**RE: Response Letter  
100 Duchaine Boulevard  
New Bedford, Massachusetts**

We have enclosed a response letter, revised Site Plans and other documents in response to the comment letter prepared by Nitsch Engineering, Inc. dated May 9, 2016 in regards to their review of the Site Plans.

**SITE PLAN**  
100 DUCHAINE BLVD.  
ASSESSORS MAP 134 LOT 5  
NEW BEDFORD, MASSACHUSETTS  
PREPARED FOR:  
CHRISTIAN FARLAND  
401 COUNTY STREET  
NEW BEDFORD, MA 02740

**OVERFLOW SPILLWAY DETAIL**

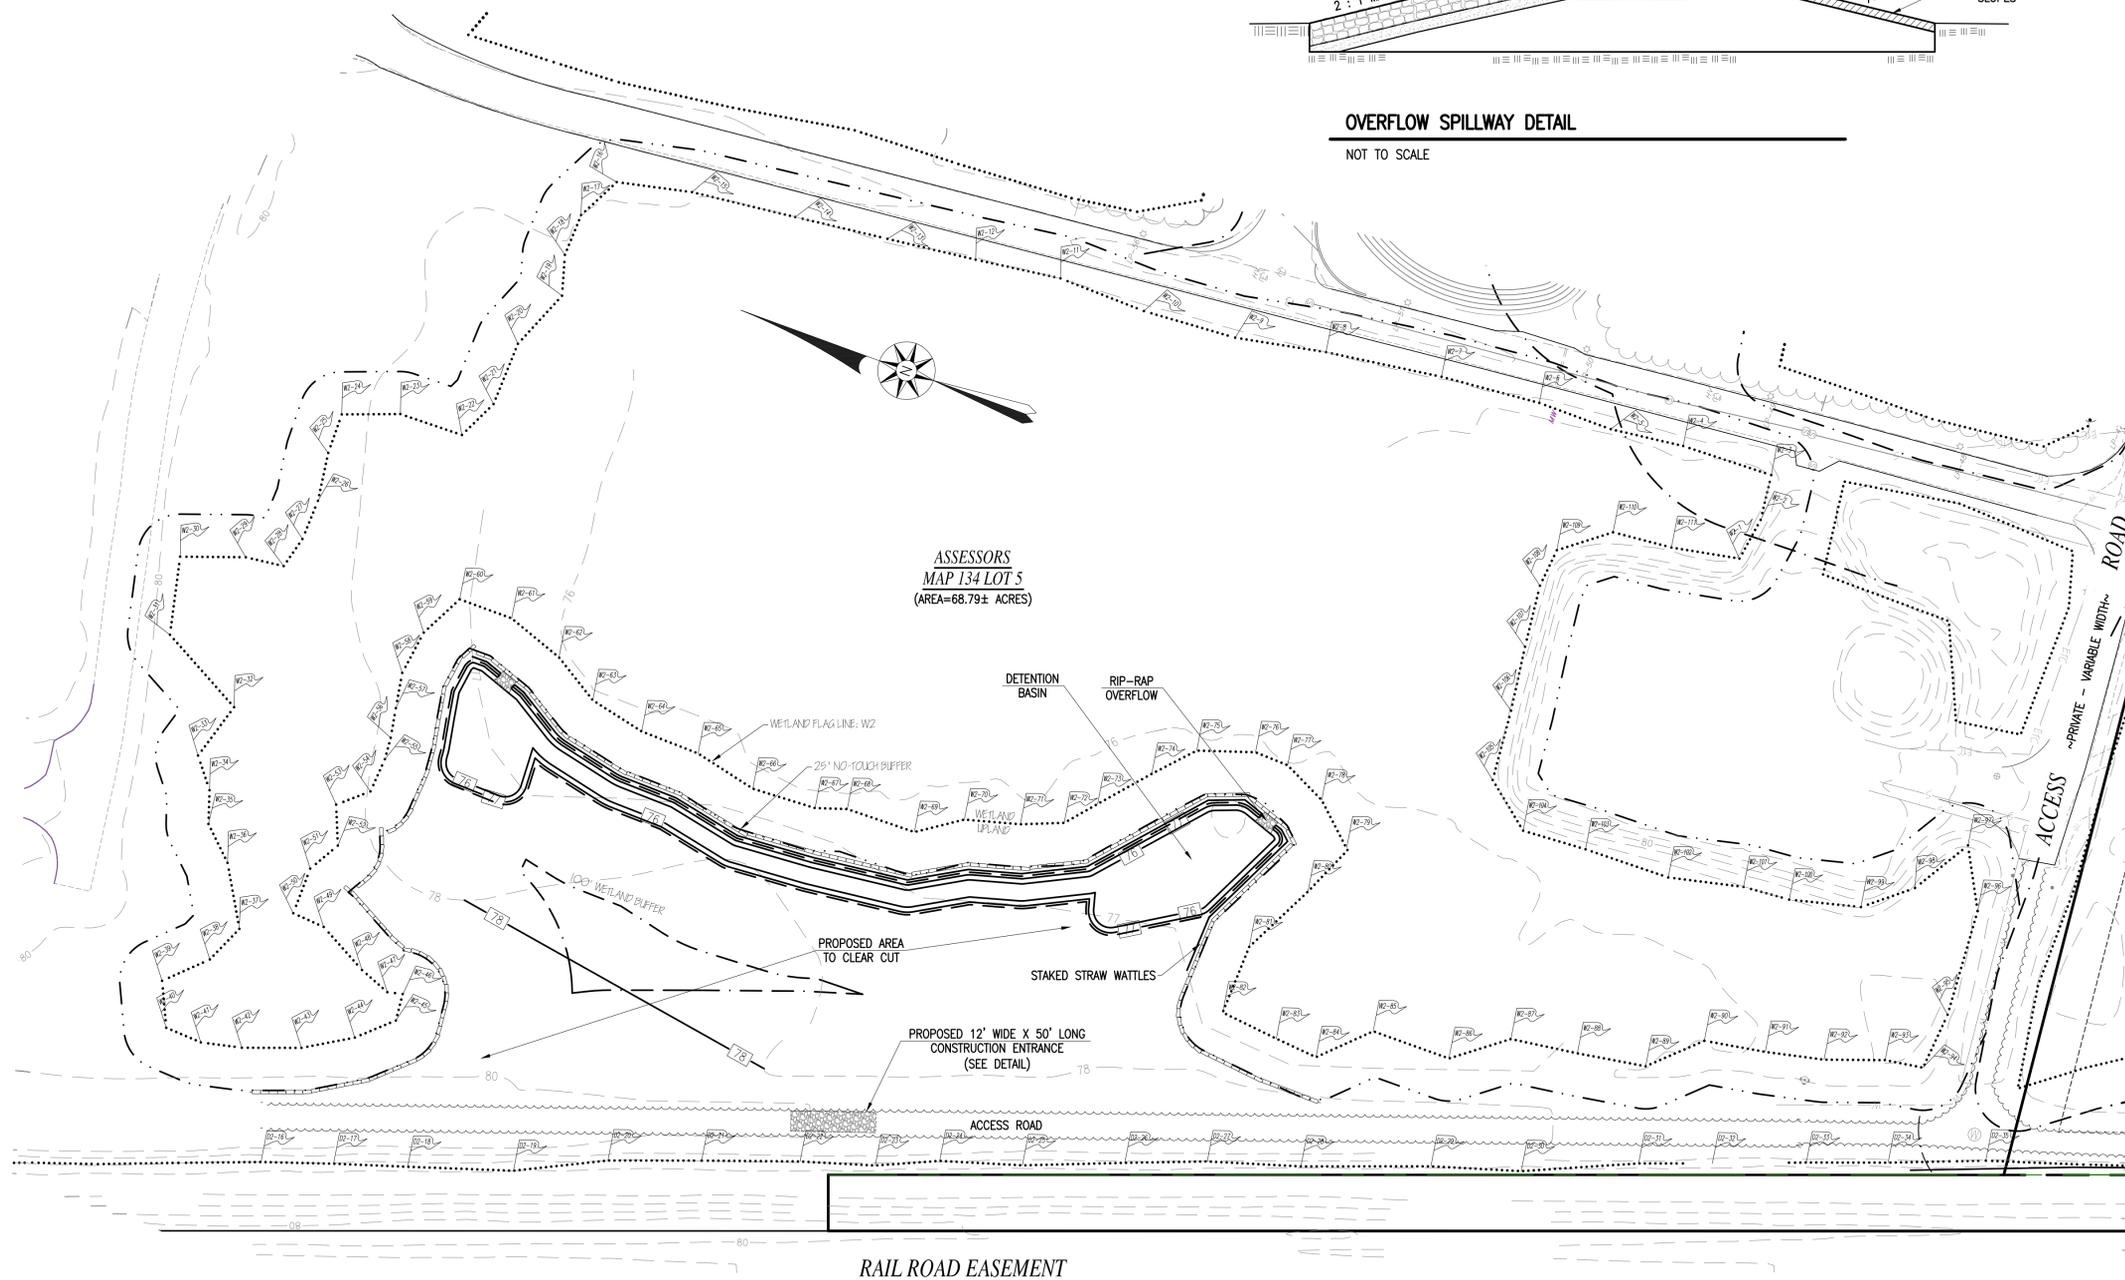
*The plans should include a detail of the overflow weirs.*

**Farland Corp has revised the plans to include a detail of the overflow weirs.**
